World Forum for Harmonization of Vehicle Regulations**Working Party on General Safety Provisions****119th session**

Amendments to regulations on buses and coaches:**UN Regulation No. 107 (M₂ and M₃ vehicles)****Proposal for the 09 series of amendments to UN Regulation
No. 107 (M₂ and M₃ vehicles)****Submitted by the expert from Spain***

Model A
(See paragraph 4.4. of this Regulation)

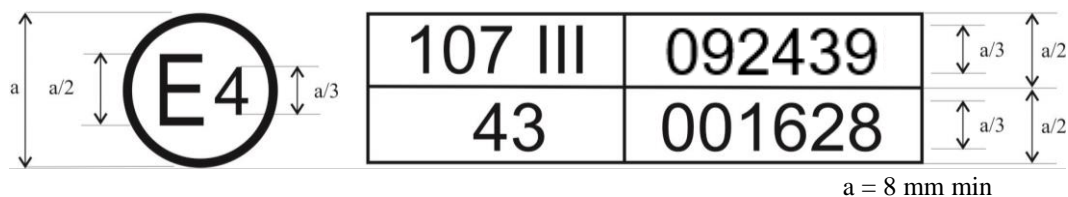
The above approval mark affixed to a vehicle shows that the vehicle type concerned has, with regard to its constructional features, been approved in the Netherlands (E 4) for Class III, pursuant to Regulation No. 107 under approval number 092439. The approval number indicates that the approval was granted according to the requirements of Regulation No. 107 as amended by the 09 series of amendments.

Model C

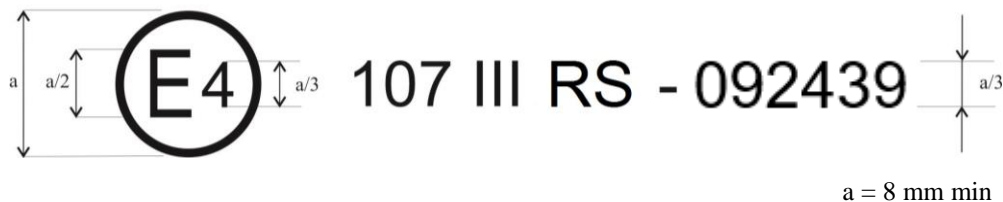
The above approval mark affixed to a vehicle bodywork shows that the bodywork type concerned has, with regard to its constructional features, been approved separately in the Netherlands (E 4) for Class III as a separate bodywork (letter S), pursuant to Regulation No. 107 under approval number 092439. The approval number indicates that the approval was granted according to the requirements of Regulation No. 107 as amended by the 09 series of amendments."
